GREAT EVENTS CATERING INC.
4020 7TH ST SE
BLOCK 19, PLAN 11JK, LOT 3B

4020 7TH ST SE
PROJECT #D25-208
DEVELOPMENT PERMIT
JUNE 16, 2026

PRIOR TO DECISIONS REQUIREMENTS #2
REVISIONS TO PLANS FOR DEVELOPMENT PERMIT
APPLICATION DP#2025-07177 RE: EXTERIOR
RENOVATIONS AND CHANGES TO SITE PLAN

AMENDED DRAWINGS

4 BF PARKING STALL
DP-04(a) 1:300 ON 11 x 17

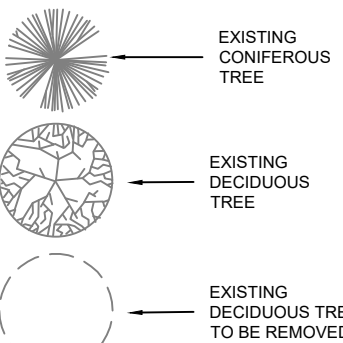
- DP-04(a) - DP-04(d) - PARKING STALLS ALONG THE WEST PROPERTY LINE HAVE BEEN LENGTHENED TO A DEPTH OF 5.49m
- DP-04(a) - DP-04(a) - BARRIER-FREE PARKING STALLS HAVE BEEN ANGLED TO PROVIDE CONSISTENCY WITH THE OTHER PARKING STALLS ALONG THE WEST PROPERTY LINE
- DP-04(d) - DRAWING ADDED TO AMENDED SET
- DP-04(d) - DIRECTIONAL ARROWS HAVE BEEN ADDED ALONG THE WEST PROPERTY LINE PARKING STALLS TO DICTATE THE VEHICLE DIRECTIONAL TRAVEL
- DP-04(d) - LOADING VEHICLE DESCRIPTIONS
